Product Change Notification / NTDO-04AXQA020

CCB 6547 Final Notice: Release of updated Libero SoC v2023.2 for selected products in the PolarFire FPGA, PolarFire SoC and RT PolarFire FPGA device family, including MPFxxx and RTPF device families.

Customer Notification (CN)

Subject: Important Updates in Libero SoC v2023.2 for PolarFire® FPGA, PolarFire SoC, and RT PolarFire FPGA

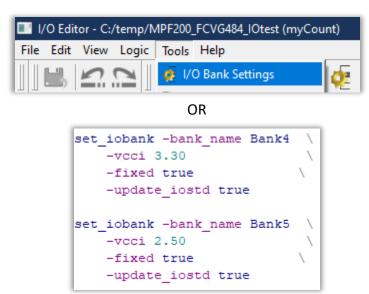
This customer notification applies to PolarFire MPF200Txx FPGAs in the FCVG484 package. Device I/O banks 4 and 5 on the FCVG484 package of MPF200T/TS/TL/TLS devices are connected to a single VDDI I/O voltage supply, as stated in the device Package Pin Assignment Table (PPAT), per the figure below.

In other words, there is no VDDI5 nor VDDAUX5 package pin on this device die and package combination. Similarly, the Libero SoC design specific pin reports do not contain separate I/O voltage supply pins for I/O banks 4 and 5.

Prior to Libero SoC v2023.2, it was possible for the user to assign different VDDI bank voltages to the two I/O banks in a Libero SoC design targeting this device. Libero SoC v2023.2 has been updated to flag this erroneous user selection and to enforce a Design Rule Check (DRC) on the VDDI assignments to the two I/O banks.

Libero SoC v2023.2, or later, will perform a DRC and issue an error if the user design attempts to assign different VDDI voltages to I/O banks 4 and 5.

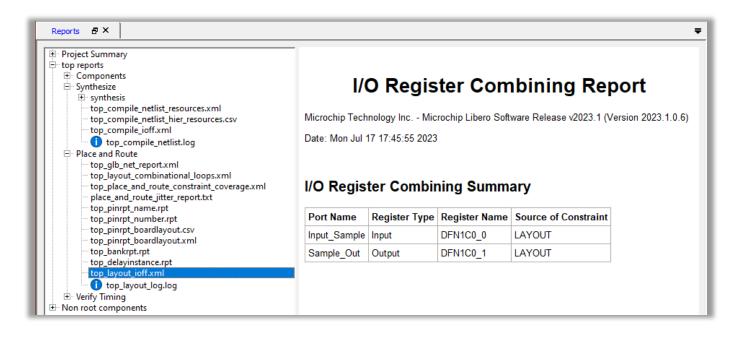
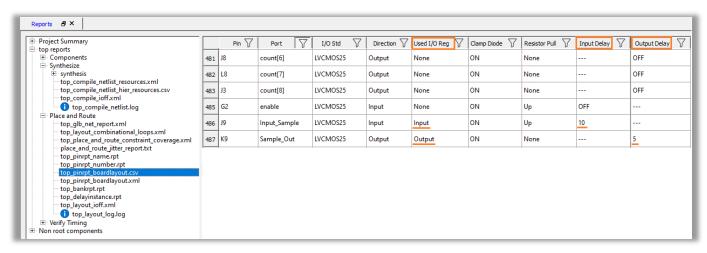
The following figures show the Libero SoC reports that can be used to identify whether programable I/O delays are used in the path of an I/O that also used I/O Registers (also known as I/O Flip-Flops, or IOFFs).

- The first figure shows an example I/O Register Combining report, <root>_layout_ioff.xml, listing the fabric FFs that have been combined into I/O Registers.
- The second figure shows an example Pin Report with the "Used I/O Reg", "Input Delay", and
 "Output Delay" columns highlighted, indicated that this example does indeed use
 programmable I/O delays in the path of combined IOFFs.

Designs using Libero SoC v2023.1, or earlier, that do contain programmable I/O delays in the path of a combined IOFF would not have the programmable I/O delays reflected in the programmed device. If the programmable I/O delay was required for correct interface functionality in hardware, then communication issues could be observed. Furthermore, the Libero SoC STA results would have been performed with the inclusion of the programmable I/O delays, however the STA result would not match the programmed device I/O timing in HW.

Use Libero SoC v2023.2 to re-run the "Generate FPGA Array Data" design flow step, and subsequent design flow steps to obtain a programming bitstream that will honor the programmable I/O delay settings in a programmed device.
